PARTS & SERVICE NEWS

REF NO. AT04272

SUBJECT: IMPROVED HYDRAULIC CYLINDER WITH INCREASED DUST RESISTANCE FOR USE ON WA1200-3

APPLICATION: WA1200-3 Wheel Loader S/N 50001 thru 50028

Fig. 1

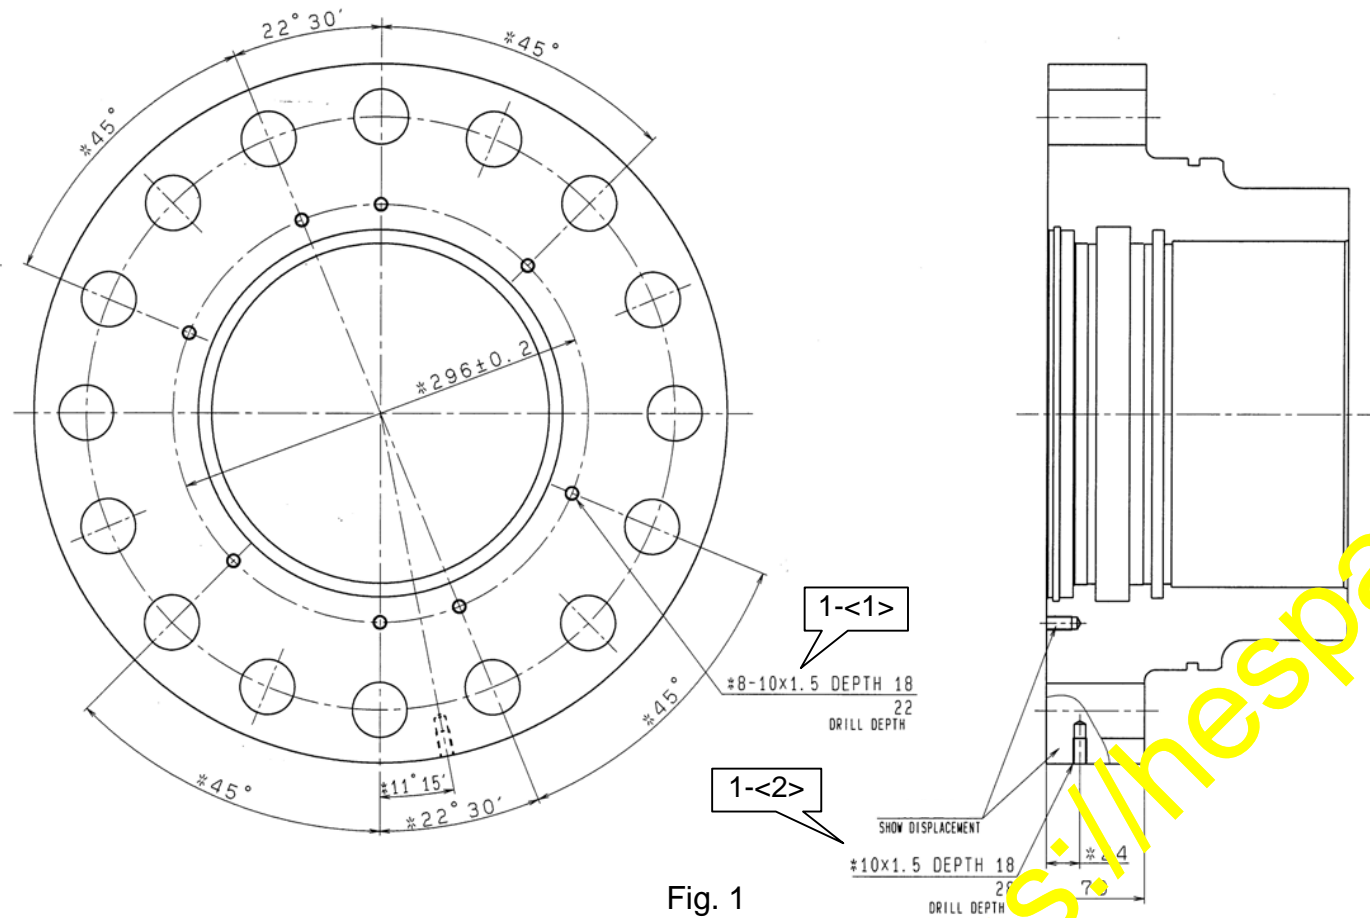
Add tap holes to the disassembled cylinder head (707-27-36020) as shown below.

- <1> 10 x 1.5 in front: 8 pieces (Take care of the angle in the circumferential direction.)
- <2> 10 x 1.5 in side: 1 piece (Take care of the angle in the circumferential direction)

Fig. 2

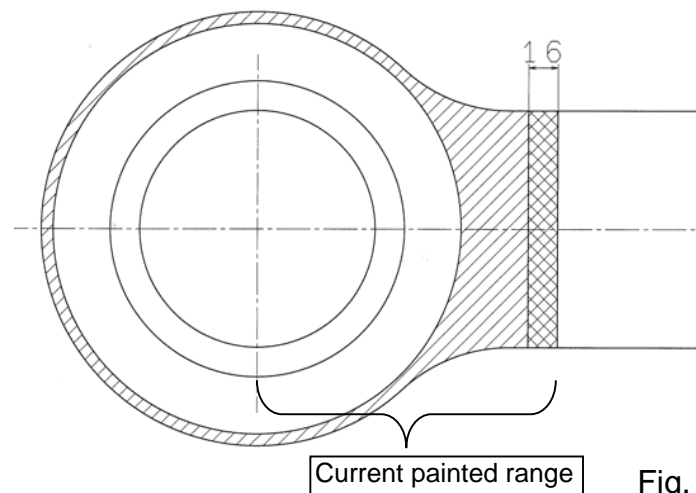
Remove the painting of the rod (707-58-24012) from the edge 16 mm to expose the plating part.

Fig. 3

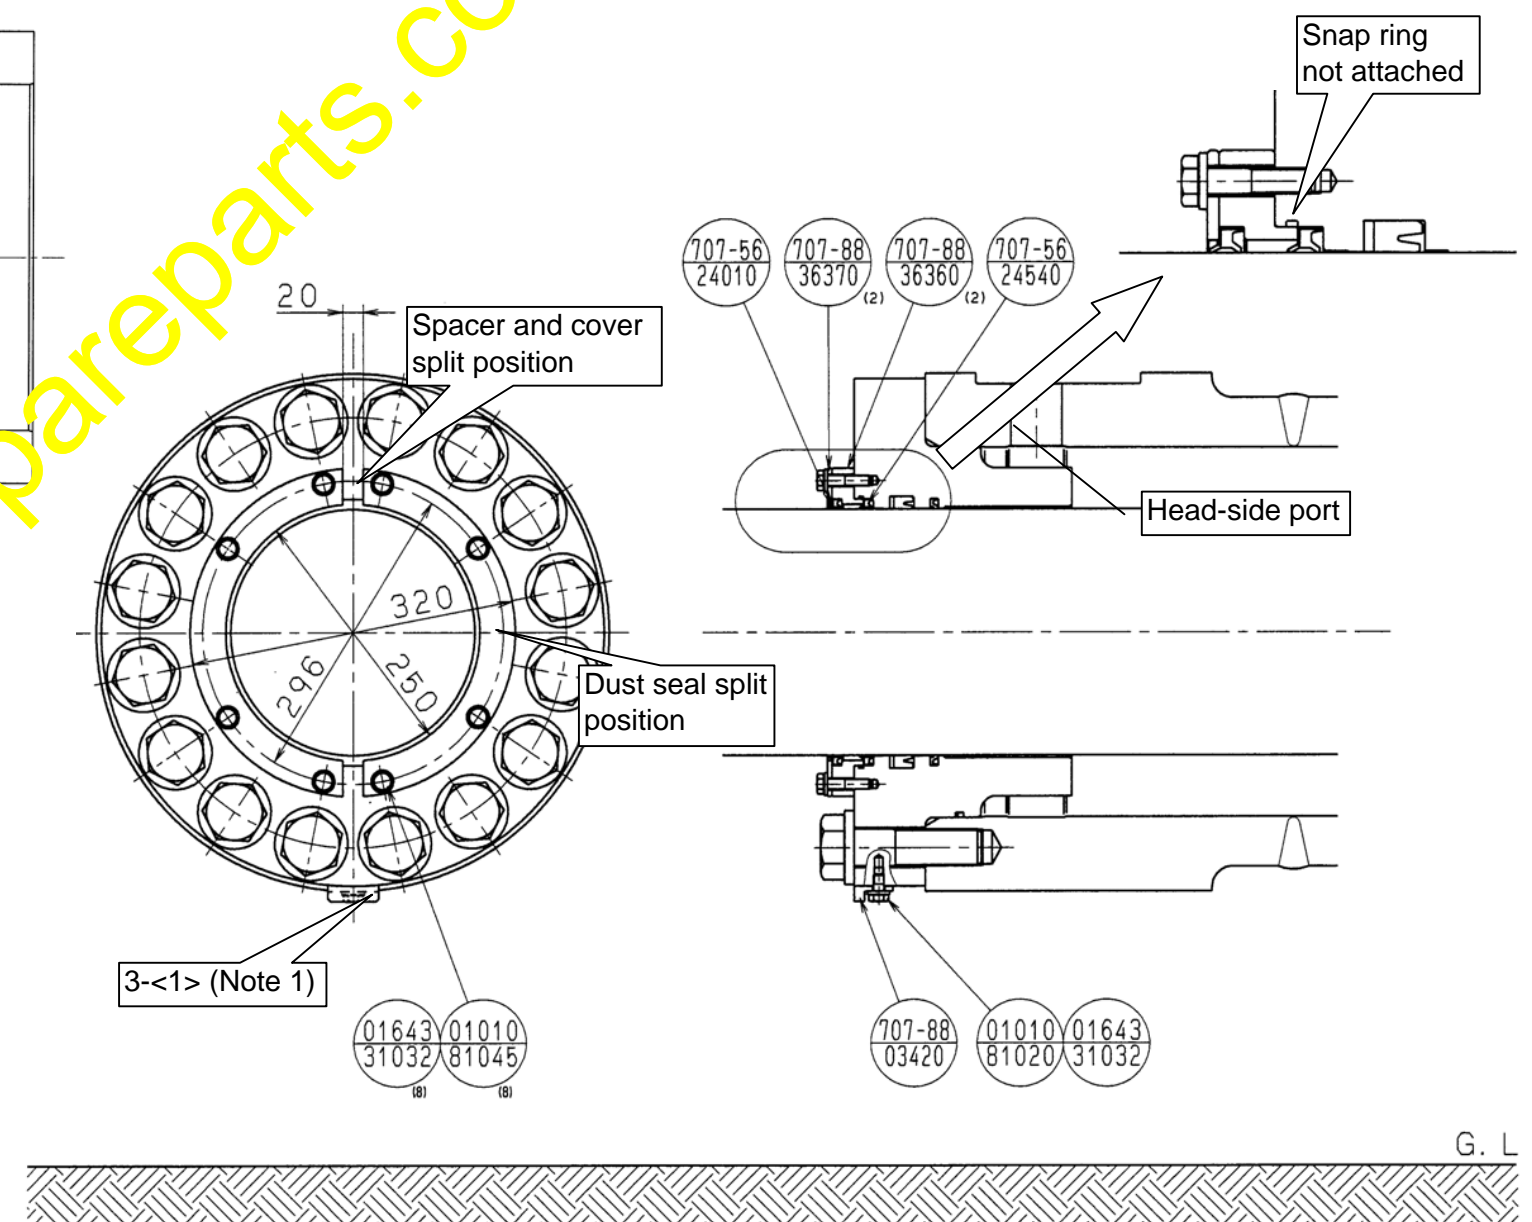
- <1> Reassemble the cylinder head with tap holes reworked as the way it was.
(Note 1) Confirm that the tap hole (10 x 1.5) for attaching the plate (707-88-03420) is in the G.L. side.
(Note 2) Dispose of the snap ring (07179-17260) without inserting it.
- <2> Set two spacers (707-88-36360) along the snap ring groove.
(In this case, take care of the position in the circumferential direction.: See Figure 3.)
- <3> Attach the dust seal (707-56-24010) along the groove of 707-88-36360.
(In this case, displace the 707-88-36360 two-split position and seal split position 90 degrees.)
- <4> Set the cover (707-88-36370), then fix it with a bolt.
Bolt tightening torque: 59 - 74 Nm (Use torque wrench)
- <5> Attach the plate (707-88-03420) in the side of the cylinder head.
Bolt tightening torque: 59 - 74 Nm (Use torque wrench)

Fig. 4

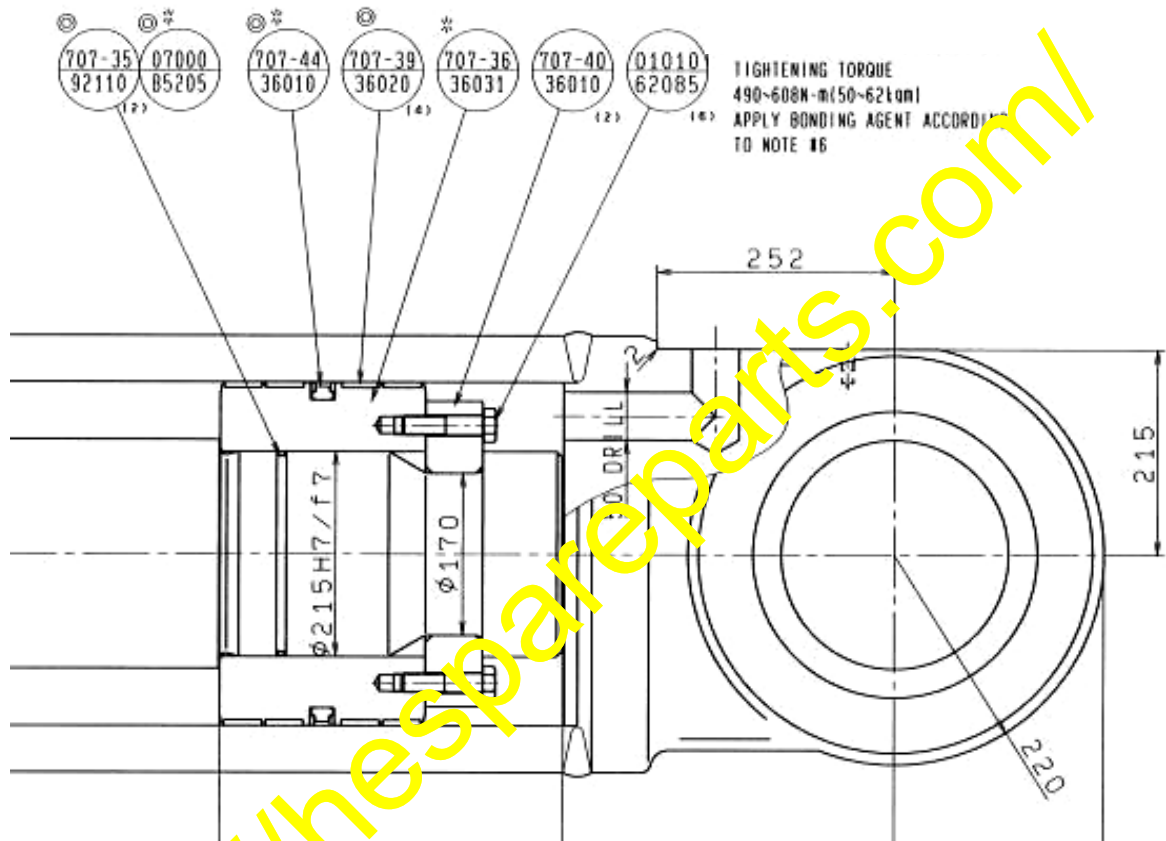
4. Replacement parts in the piston section

Replacement parts in the piston section: Parts marked * and parts marked ©

(Parts marked *; Newly arranged parts, Parts marked ©; KIT parts)
